ALLENDALE CHARTER TOWNSHIP PLANNING COMMISSION MEETING

To: Allendale Charter Township Planning Commission

Pursuant to your December 5, 2022 meeting, attached is a final site plan and related application for a special use permit from John and Rebecca Bakale to excavate approximately 280,000 cubic yards of sand and gravel 12943 76th Avenue and 12673 76th Avenue, parcel numbers 70-09-16-100-047 and 70-09-16-100-061, respectively, which will result in the formation of a pond. As you are aware, the subject property currently contains their personal dwelling and pole barn, and is located within the Agricultural and Rural Zoning District.

12943 76TH AVE, ALLENDALE, MI 49401 FIGURE 2

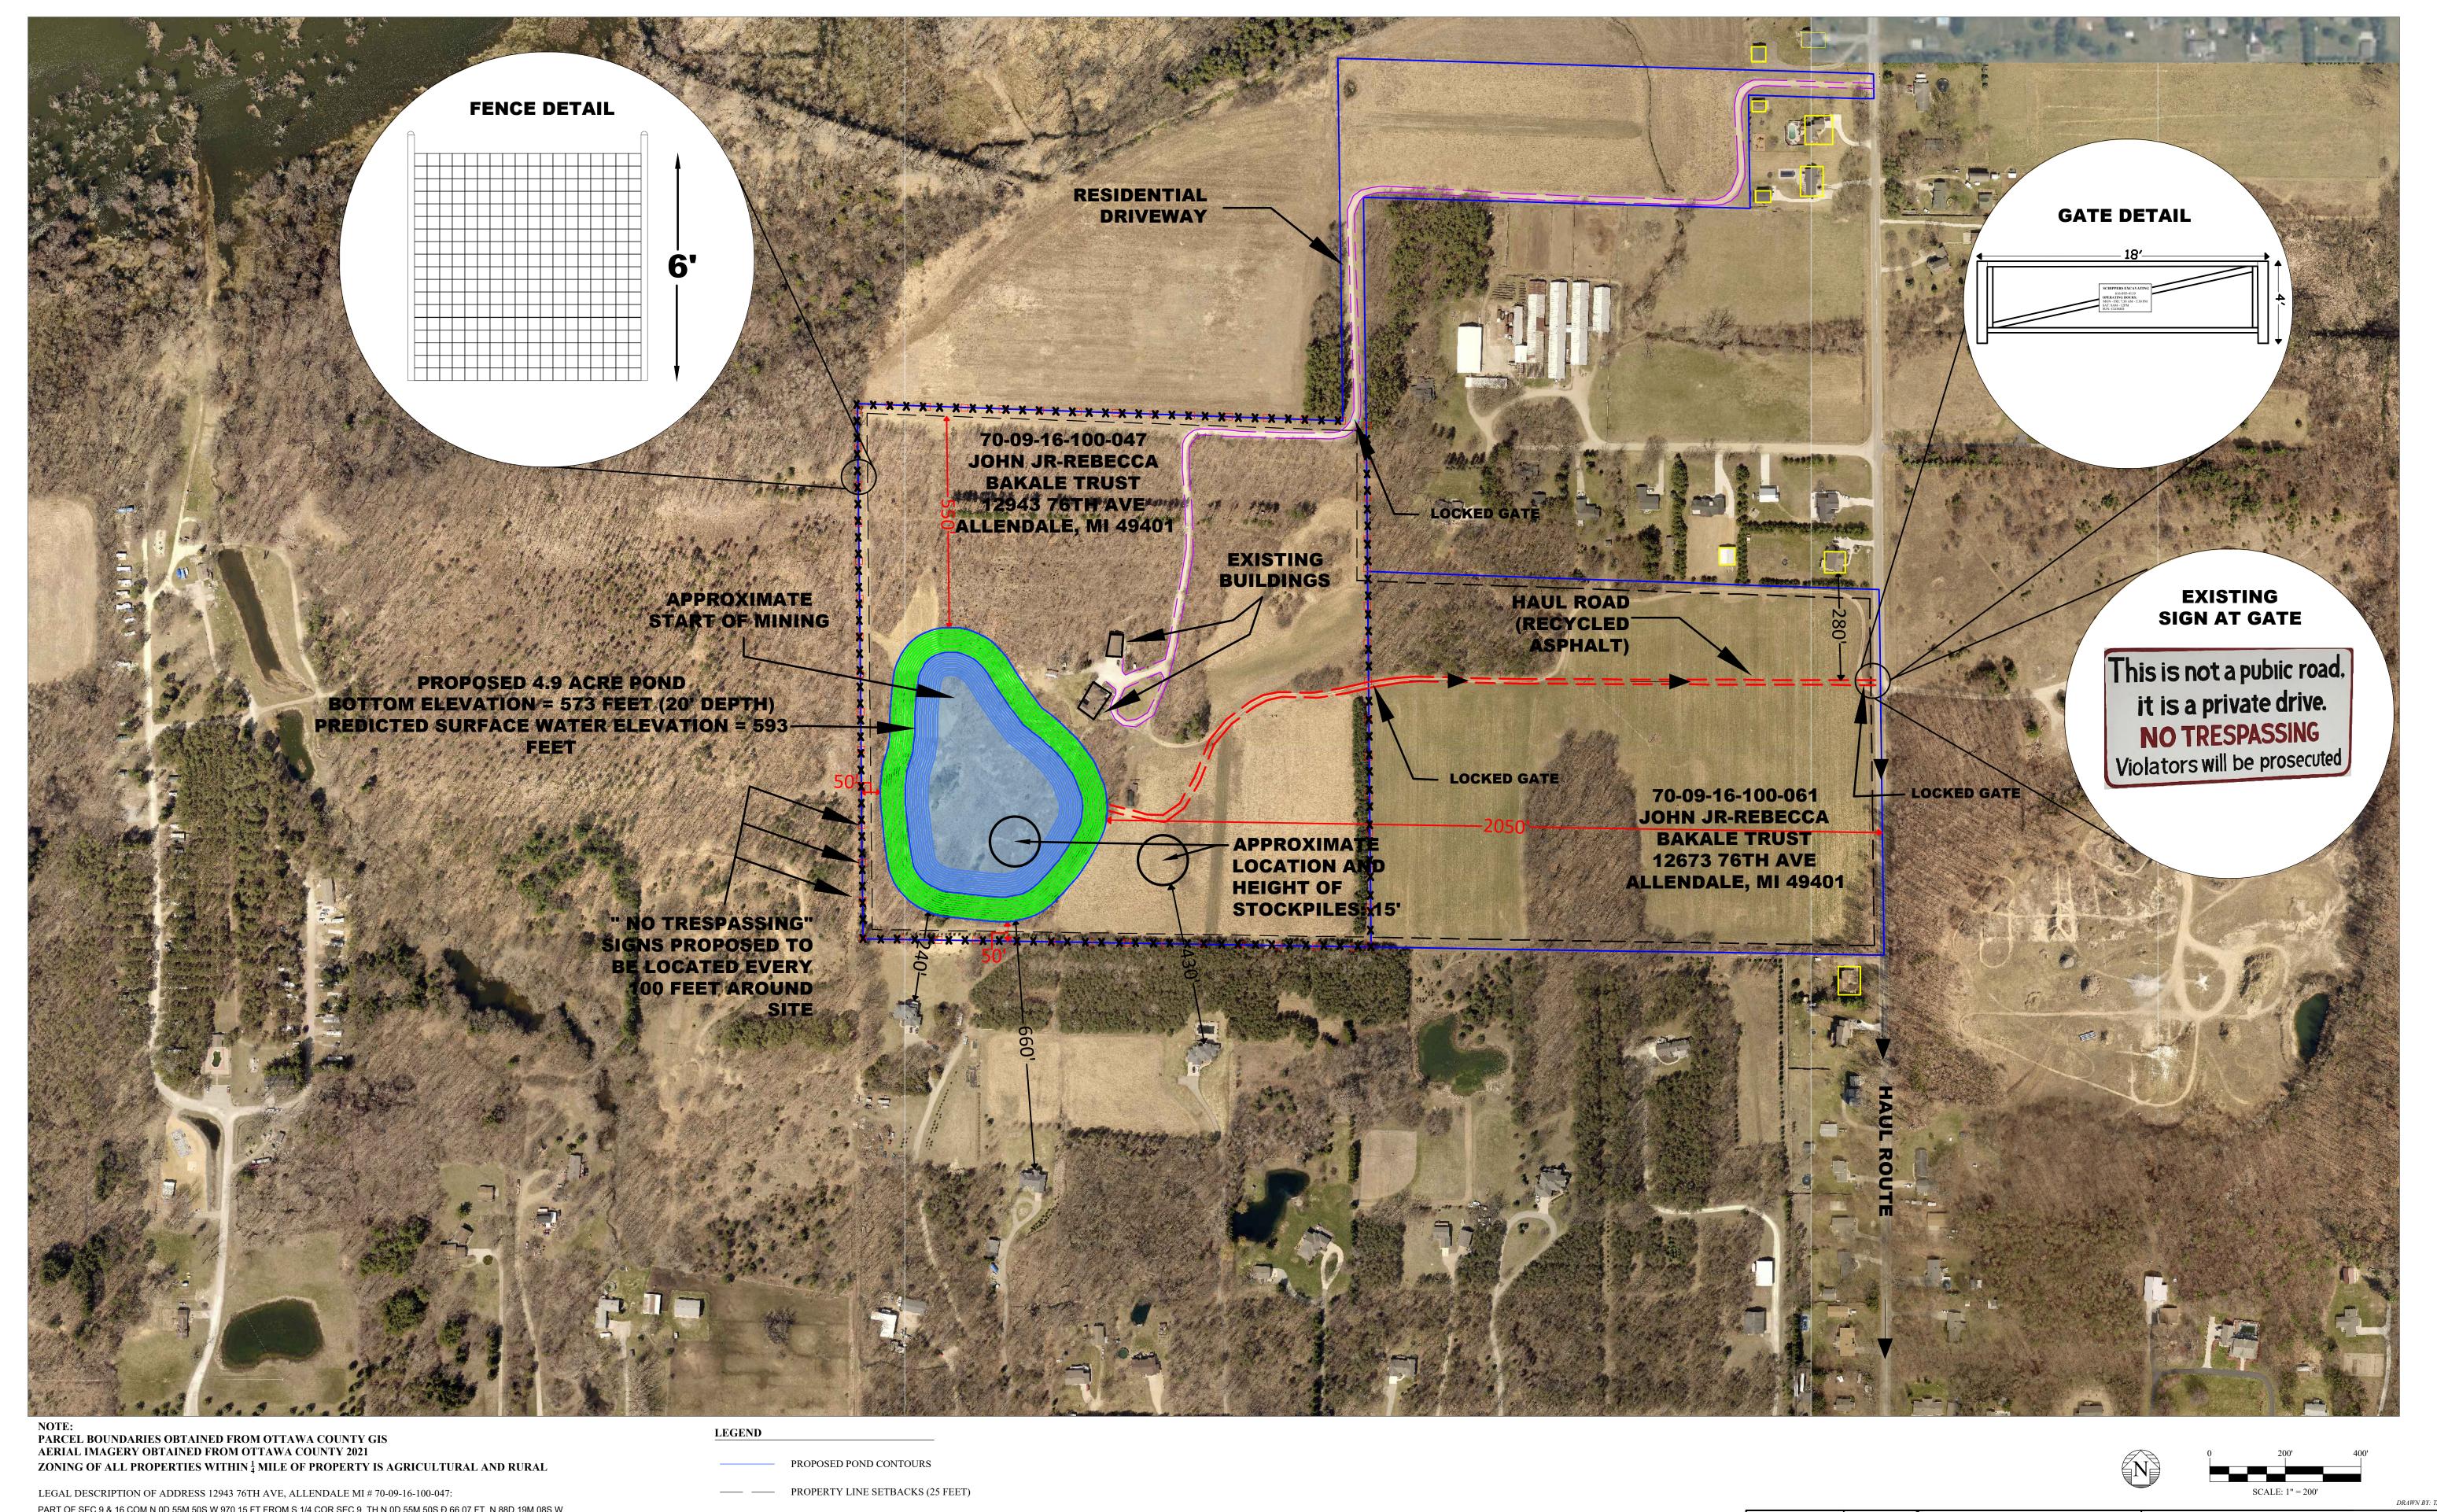
• F2a.ii – Provide dimensions of both the subject property and adjacent property (if internal truck road is not modified)

• F2a.vi – Provide for all parcels within 1000 feet (for both properties) and distance to dwellings and existing land uses

Included in Figure 2 Site Plan.

Included in Figure 2. The closest dwelling is approximately 240 feet south of the mining area. All parcels within ¼ mile of the Site are zoned as agricultural and rural.

MINING PLAN PARCEL #'S 70-09-16-100-047, 70-09-16-100-061 12943 76TH AVE, ALLENDALE, MI 49401

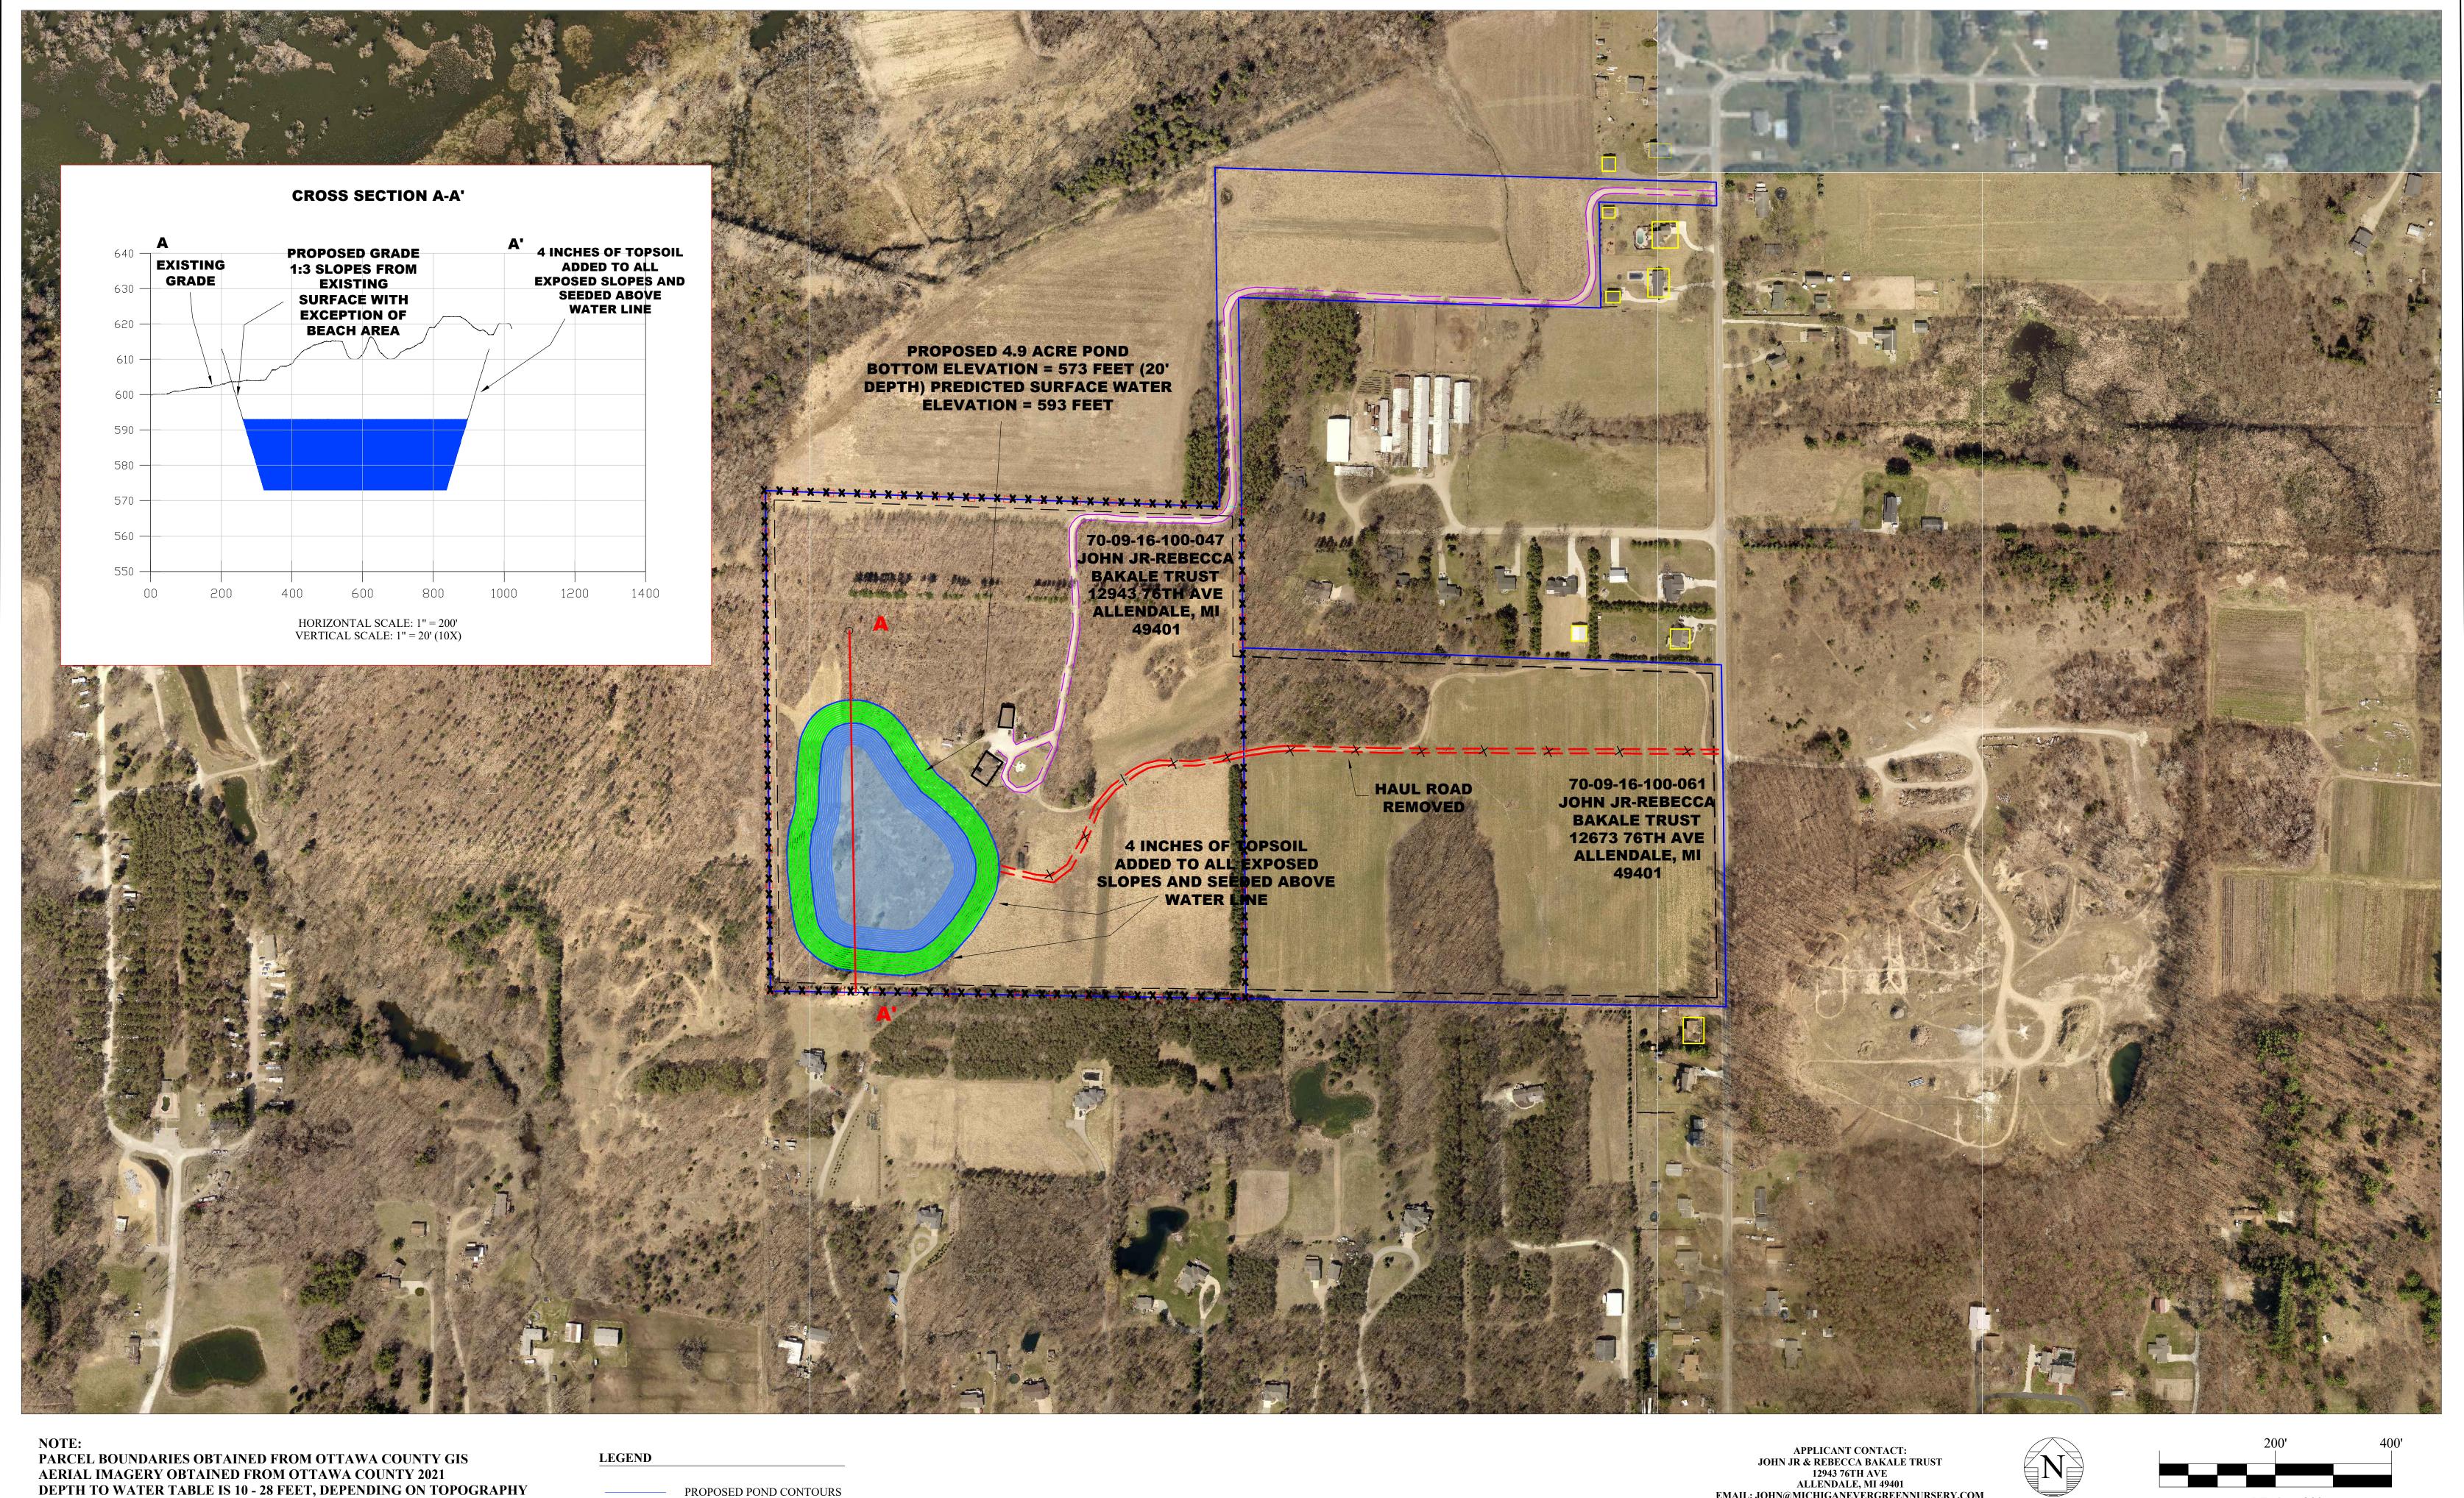
• F2bi – The south setback is illegible. Please provide clearly.

• F2bii – Provide place of beginning on the site plan drawing.

• F2biv – Provide height of stockpile on site plan

- F2bv Provide fencing details, gate details, show on plan (both properties), show illustration Included in Figure 3 Mining Plan.
- F2bvi Show to 76th Avenue

• F4a – Show all driveways

Included in Figure 3 Mining Plan.

Included in Figure 3 Mining Plan.

Included in Figure 3 Mining Plan.

Included in Figure 3 Mining Plan.

FIGURE 4

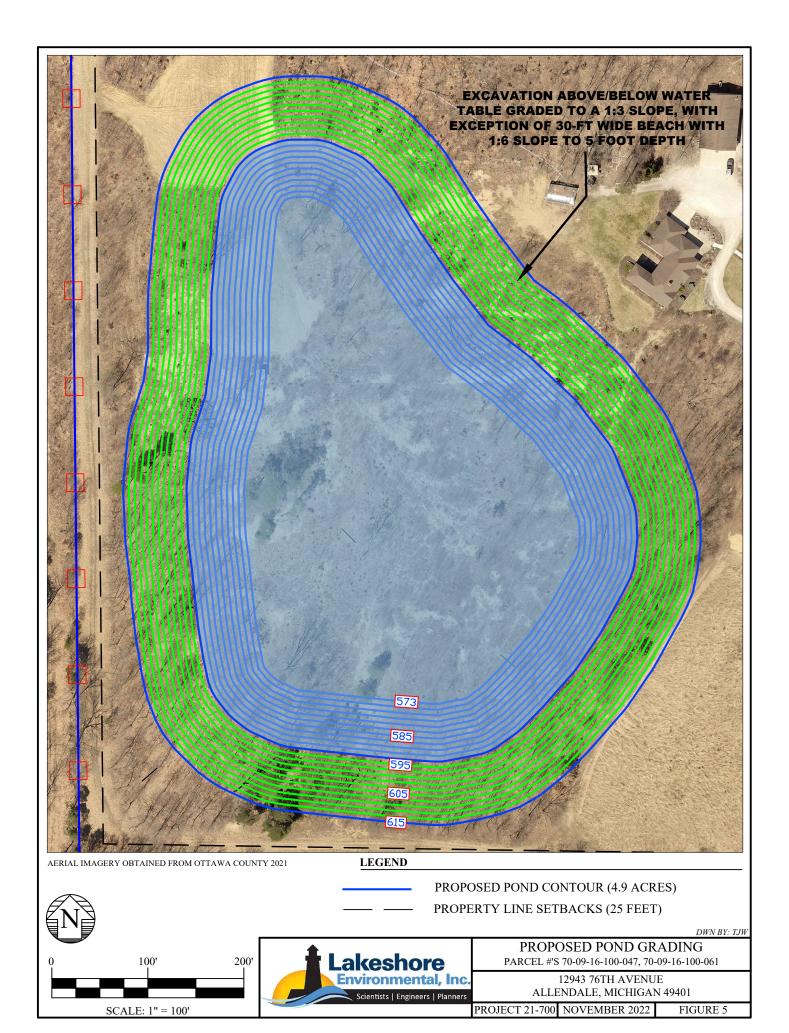
• On Figure 4 – Reclamation Plan – I plotted this drawing on $24'' \times 36''$ paper. All of the noted scales appear wrong. The plan view has a scale of 1' = 100 feet not 200 feet. Cross Section A-A has scales of 20 feet (vertical) and 200 feet (horz) not the 40' and 400' as noted. Plans need to be revised.

This error has been corrected. Included in Figure 4 Reclamation Plan.
